REV.
B

AS34671

RATIONALE

CONNECTOR, PLUG, ELECTRIC,
CRIMP TYPE, PUSH-PULL COUPLING,
SERIES 3 (CLASS L AND E)

FIGURE 1 - CONNECTOR CONFIGURATIONS AND DIMENSIONS (CONNECTOR VIEW)

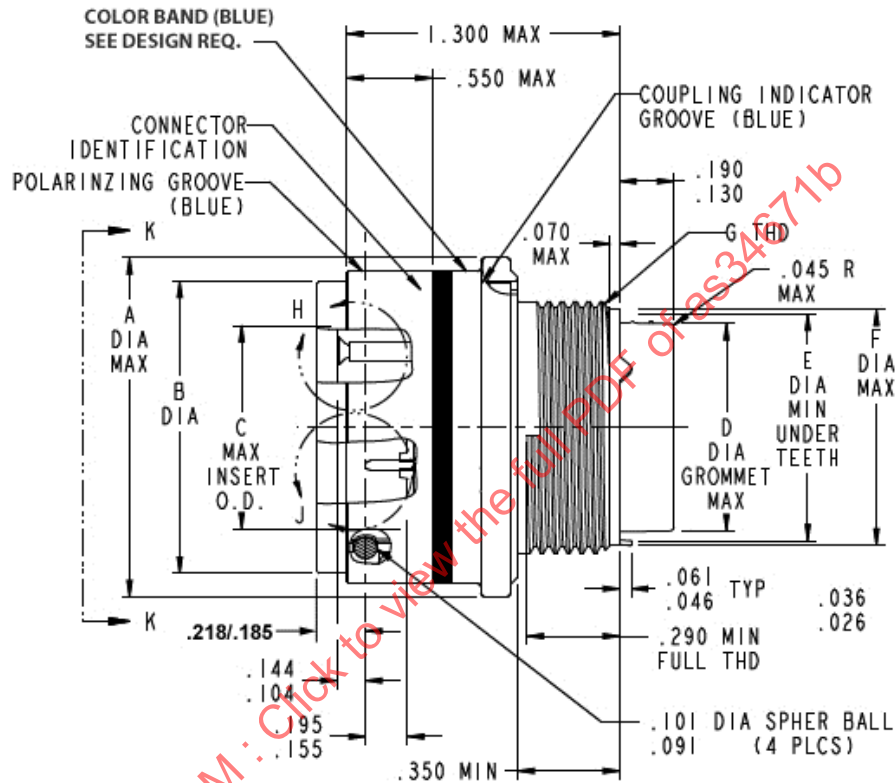
REVISION IS REQUIRED TO CORRECT THE FEATURE LINE FOR THE .218-.185 DIMENSION IN FIGURE 1, THE LEFT SIDE BOUNDARY LINE SHOULD BE THE END OF THE SHELL.
